Interface Pricing on PJM–MISO Seam

**WPPI Response to Potomac Economics,
MISO and PJM Presentations**

PJM–MISO Joint and Common Market Stakeholder Forum

January 24, 2014

Potomac Economics' Proposal

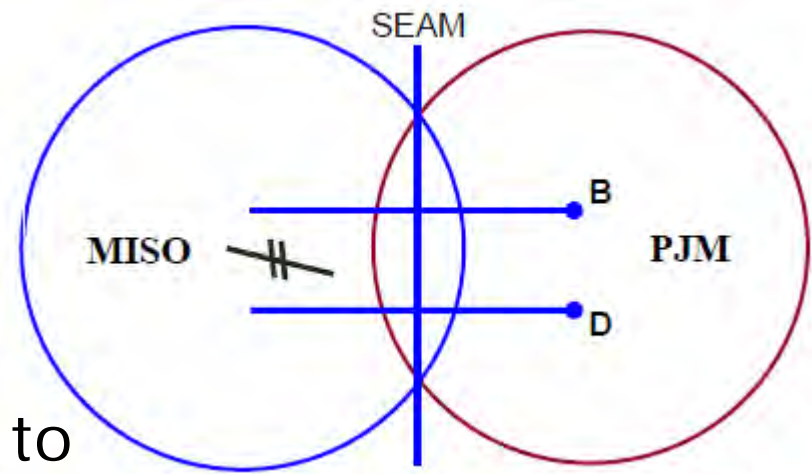
- Potomac Economics suggests that eliminating external-constraint congestion from non-Monitoring RTO's (NMRTO's) price will result in congestion being counted exactly once
- This would be the case if NMRTO adopted MRTO's Interface definition (similar to WPPI Proposal), but I understand IMM's proposal to be that NMRTO Interface should be based on Reference Bus for apportioning LMP into Energy, Congestion & Loss components
- Resulting separation between Interface definitions means congestion will generally still be over- or under-counted to some extent
